Planning Commission

September 12, 2024
Packet Addendum #2

ITEM: Coal Creek Village Mixed-Use Development

REQUEST: Approval of Resolution 10, Series 2024 Recommending to the Planning Commission Approval of a Preliminary Planned Unit Development (PUD), Preliminary Plat, an Ordinance Rezoning a Portion of the Property from CC-MU (Commercial Community – Mixed Use) and R-M (Residential Medium Density) to MU-R (Residential Mixed Use), Amending Exhibit A, Land Use Exhibit, Referenced in LMC Chapter 17.14, and a Special Review Use to permit multi-unit dwellings on the ground floor in the MU-R zone district.

Site layout with proposed right-of-way connections, shown in blue

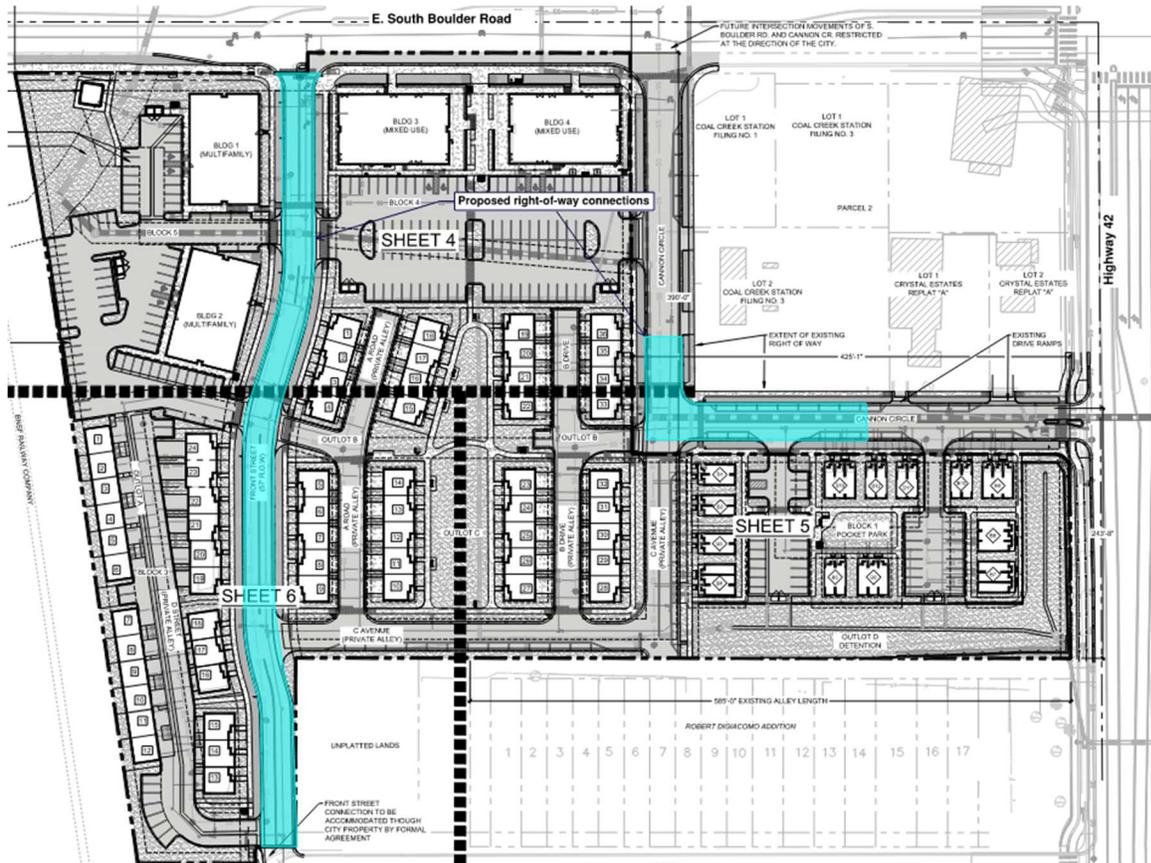
1) Traffic inside the Little Italy neighborhood. I am absolutely opposed to the Front St connection through Little Italy to the north into the Coal Creek Village development. Allowing traffic to and from the development to pass through the existing neighborhood would be disruptive, unsafe, busy, noisy and unnecessarily negatively impact the neighborhood. The development plan already has 2 access streets to S. Boulder Rd and 1 access to 95th St. Providing access to Griffith St directly through the Little Italy neighborhood potentially increases traffic by 100s of vehicles per day. This volume of traffic would ruin the small compact neighborhood and create a backlog of traffic at the intersection of Front and Griffith streets. Griffith St already has an unsafe situation in the morning and afternoon when it is flooded by vehicles and students going to Louisville Middle School. Griffith St., also, already backs up with traffic for each passing train. I am in support of an access on Front St into the development for emergency response, pedestrians and bicycles. I am not in support of increased cars. Perhaps gated or pylons or the like of other limiting access that has been employed by the city elsewhere could be used here.

1. **Please** remove motorway connections to Front St. and the Little Italy alley behind Harper St. These roads are not designed for increased traffic and parking, especially with LMS within two blocks. These connections should be revised to multi-use pathways with emergency vehicle and pedestrian access only. If this moves forward, it will negatively impact our neighborhood's children who play in the sleepy little old town streets of Little Italy. It will undermine our property value and increase traffic, potential accidents and harm to our kids.
Please keep the entry/exit for this development to South Boulder Road and Highway 42 only.

1. Please, please remove the Front street road thoroughfare, and all motorway connections to Front St. and the Little Italy alley behind Harper Street. Our neighborhood and our streets are wonderfully sleepy now and are not designed for increased traffic and parking, especially with the nearby Middle School. A new design would alter our neighborhood in uncountable ways, including our property we have spent years making beautiful and cherish. These connections should be revised to multi-use pathways with emergency vehicle access and pedestrian traffic only. The Harper Street residents with north garage/property entries will still need access. Please understand, If this moves forward as proposed, it will negatively impact our quality of life and property values. I also want to point out that LMS drop off and pick up should also be considered, as this is currently also a problem with traffic. In light of these points, Please keep the entry/exit for this development to South Boulder Road and Highway 42 only, near the commercial areas.

1. Remove motorway connections to Front St. and the Little Italy alley behind Harper St. These roads are not designed for increased traffic and parking, especially since Louisville Middle School students are expected to walk to school (no bus) within these blocks. These connections should be revised to multi-use pathways with emergency vehicle access only.

First, and most importantly, Little Italy is strongly opposed to a connected motorway along Front St. between the Coal Creek development and Little Italy neighborhood. We propose that the road be designed only for emergency vehicle access but restricted to bikes and pedestrians at all other times, either through the use of pylons or a gate. Without this important safety measure, motorists will cut through the Little Italy neighborhood, reducing safety and increasing traffic substantially in a small, historic area that was not designed to accommodate throughway traffic. As currently planned, the Coal Creek development has three entrance and exit locations onto South Boulder Road and Highway 42. There is no need for additional auto traffic through the Little Italy neighborhood. With 188 dwellings planned this would completely alter the character and safety of the historic neighborhood, and impact school drop-off at Louisville Middle School. A previous development on Weldon Way in Louisville created an unsafe accessway and the City had to retroactively close this connection. Little Italy asks that this connection be removed in an amendment before approval is granted, not retroactively once it has become a problem as in the Weldon Way development.
